APPLICATION NO.	FILING DATE	FIRST NAMED INVENTOR	ATTORNEY DOCKET NO.	CONFIRMATION NO.
10/659,104	09/09/2003	Alan Qing Zhu	33380.007C	4331
21907	7590	03/30/2005	EXAMINER	
ROZSA & CHEN 15910 VENTURA BOULEVARD SUITE 1601 ENCINO, CA 91436			GARCIA, ERNESTO	
			ART UNIT	PAPER NUMBER
			3679

DETAILED ACTION

FIG. 4

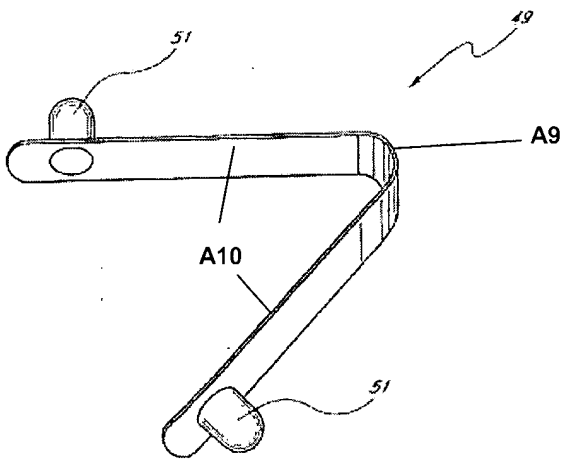
Regarding claim 1, Larsen discloses, in Figures 1E, 4 and 7, a modular picket fence comprising at least two spaced apart vertical posts (col. 6, lines 14-16), at least

two spaced apart horizontal tubular rails **24**, , spaced apart vertical tubular pickets **22**, and locking means **49** for locking the pickets **22** to the rails **24**. Each of the rails **24** has spaced apart apertures **46**. The apertures **46** on the rails **24** are aligned. The pickets **22** are secured in mutually parallel relationship to the rails **24**. Each of the pickets **22** has two opposite end portions **26** respectively inserted into the apertures **46**. Each of the end portions **26** has at least two oppositely disposed and aligned transverse apertures **33** (col. 7, lines 65-67).

The locking means **49** is for respectively locking each of the end portions **26** of each of the pickets **22** to the rails **24**. The locking means **49** comprises a one-piece generally U-shaped spring clip having a bent middle portion **A9** and two opposite end portions **A10** each having an outwardly protruding stopper **51**. Each stopper **51** has a right-angle side **A13**. The spring clip is inserted into each of the end portions **26** of the pickets **22** with each stopper **51** respectively protruding through the two transverse apertures **33** of the pickets **22**. Each of the end portions **26** of each of the pickets **22** is respectively inserted into one of the apertures **46** of the rails **24**. Each stopper **51** is respectively inserted in the end portions **26** of the pickets **22** respectively extending through the transverse apertures **33** of each of the end portions **26** of each of the pickets **22**, and also extending into and respectively engaging inside the rails **24** such that vertical movement of each of the pickets **22**, relative to the rails **24**, is prevented. However, Larsen fails to disclose attaching means for attaching the rails **24** to the posts and each stopper **51** having a ramp side.
